Access Compliance Report

Public Rights-of-Way

(Curb Ramps)

Intersection ID: 4829	Main Street: ARKLOW_RD	Cross Street: SADDLE_TRAIL_LN	Location:	N
ADA ID: 6E6367821C8A	Ramp Type: Perp	Initial Pass/Fail: Fail	Overall Compliance: No	Severity Score: 46.25
Codes/Mitigation Info/Possible Solution		Field Measurements/Component Compliance

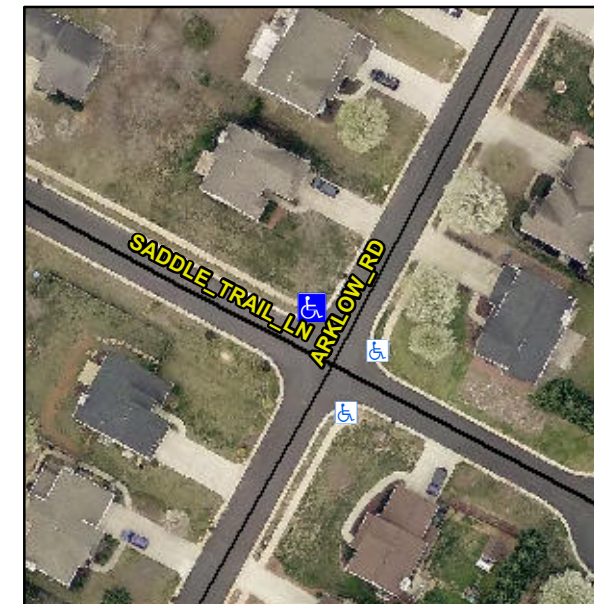
Not Found, R304.5.1, R304.2.2, R304.5.3

Compliance	Description	Data	Compliance	Description	Data
N/A	Ramp Length (in)	48.0	No	Ramp Slope (%)	13.9
No	Ramp Width (in)	37.0	No	Ramp XSlope (%)	5.1
N/A	Flare Type LT	N/A	N/A	Flare Type RT	N/A
N/A	Flare Slope LT (%)	N/A	N/A	Flare Slope RT (%)	N/A
N/A	Flare Traversable LT?	N/A	N/A	Flare Traversable RT?	N/A
N/A	Landing Length (in)	N/A	N/A	DWS Provided?	N/A
N/A	Landing Width (in)	N/A	N/A	DWS Contrast?	N/A
N/A	Landing Slope (%)	N/A	N/A	DWS Length (in)	N/A
N/A	Landing X Slope (%)	N/A	N/A	DWS Full Width?	N/A
N/A	Landing Curb? (Y/N)	N/A	N/A	DWS Offset (in)	N/A
N/A	Shared Landing?	N/A			
N/A	Gutter Ponding?	N/A	N/A	Gutter Slope (%)	N/A
N/A	Gutter Lip Ht (in)	N/A	N/A	Gutter X Slope (%)	N/A
N/A	Painted X Walk1?	No	N/A	Painted X Walk2?	N/A
	X Walk 1 Direction	To SE		X Walk 2 Direction	N/A
N/A	X Walk 1 Width (in)	N/A	N/A	X Walk 2 Width (in)	N/A
	X Walk 1 Slope (%)	3.0		X Walk 2 Slope (%)	N/A
	X Walk 1 X Slope (%)	5.7		X Walk 2 X Slope (%)	N/A

Remove & Replace Entire Ramp.
